**January 8, 2018**  
**BOARD OF COUNTY COMMISSIONERS**  
**ORANGE COUNTY, FLORIDA**  
**Y18-725-TA / ADDENDUM # 2**  
**EASTERN REGIONAL WATER SUPPLY FACILITY IMPROVEMENTS PHASE IIIB**

**Bid Opening Date: January 25, 2018**

**E311**

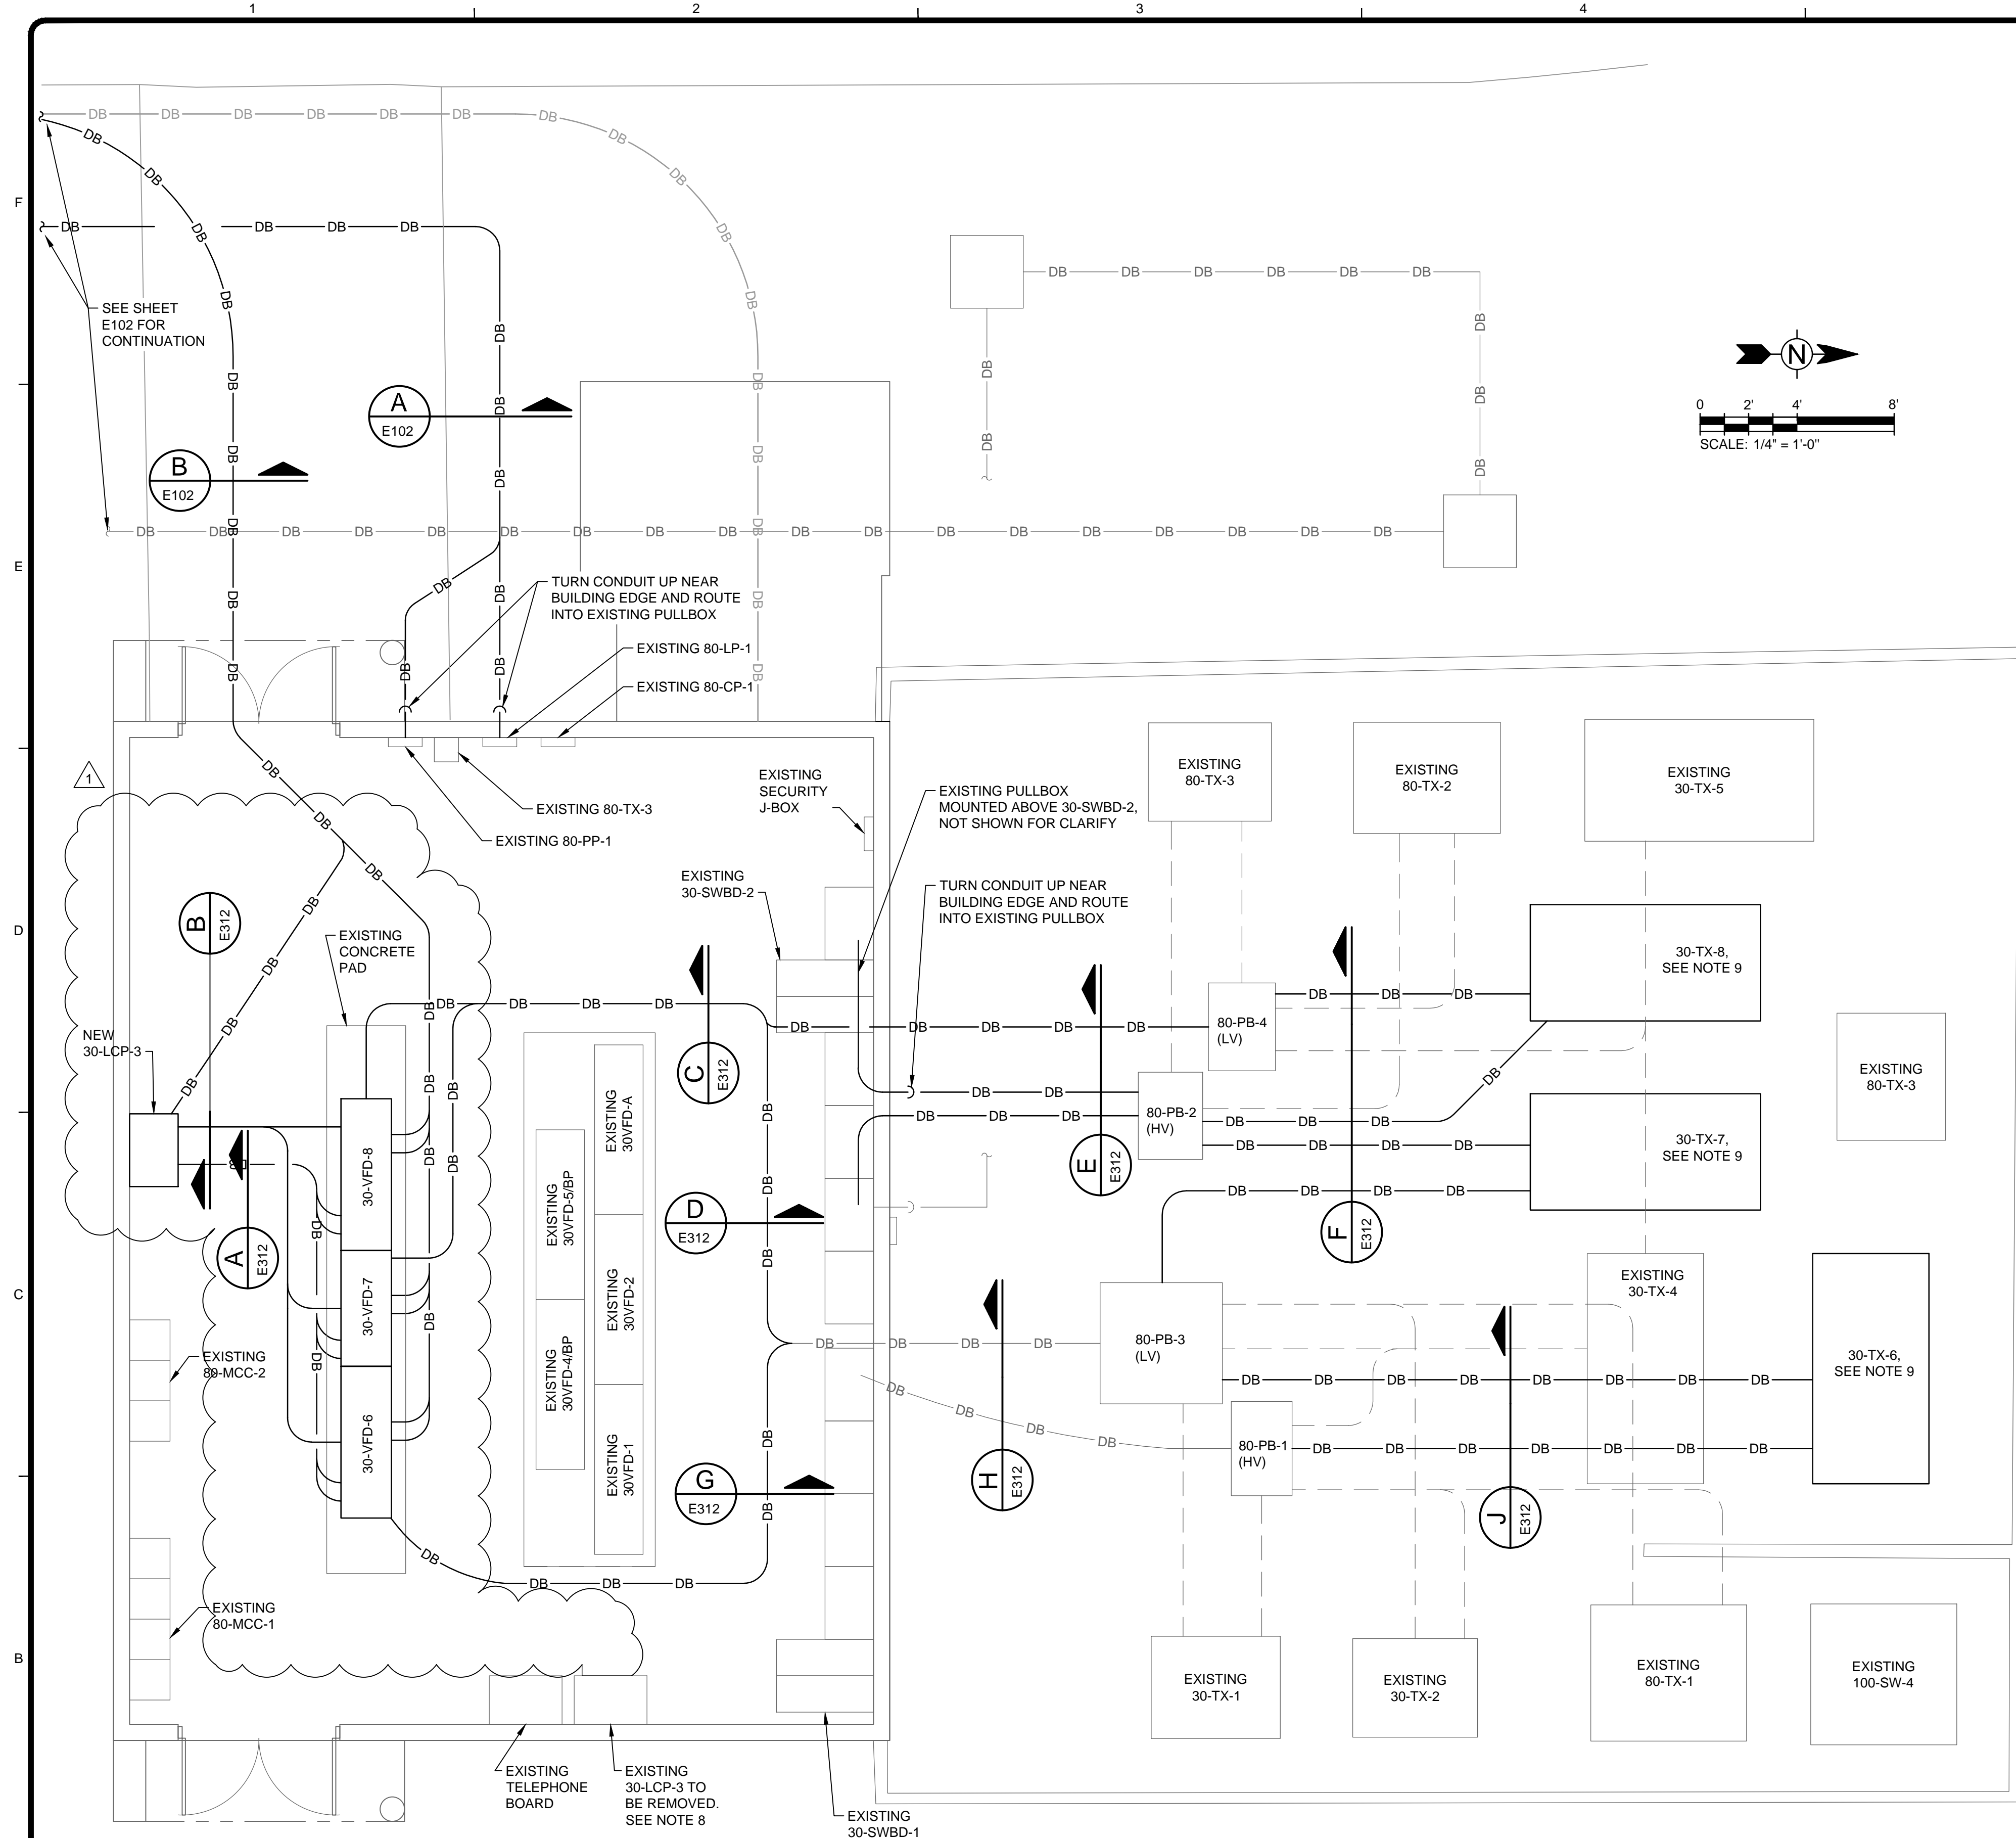
**A:** The Contractor shall provide a new PLC panel per Note 2 on drawing I-306. Refer to revised Drawings E-311 and specification modifications below in Part C and D of this addendum.

1. **Drawing Sheet E310, Note 1, modify as shown below:**
  1. ~~Locate new backplane within existing enclosure, see See Sheets I309 & I310 for additional requirements. Remove wires to/from 63-LCP-1 within existing conduits, pull in pull-strings in each existing conduit. Utilize existing conduits for new wires as shown. Mount 18" above finished floor.~~
2. **Drawing Sheet E311, Replace Drawing Sheet E311 Process 80**

**Building Power Plan with the attached Revised Drawing Sheet E311  
Process 80 Building Power Plan.**

- BUILD AND INSTALL NEW PLC CONTROL PANEL. SEE SHEET 1306 FOR ADDITIONAL REQUIREMENTS. PROVIDE TWO GARRETTCOM SWITCH WITHIN 30-LCP-3.
  - SEE GROUND MAT DETAIL ON SHEET E601 FOR ADDITIONAL REQUIREMENTS.
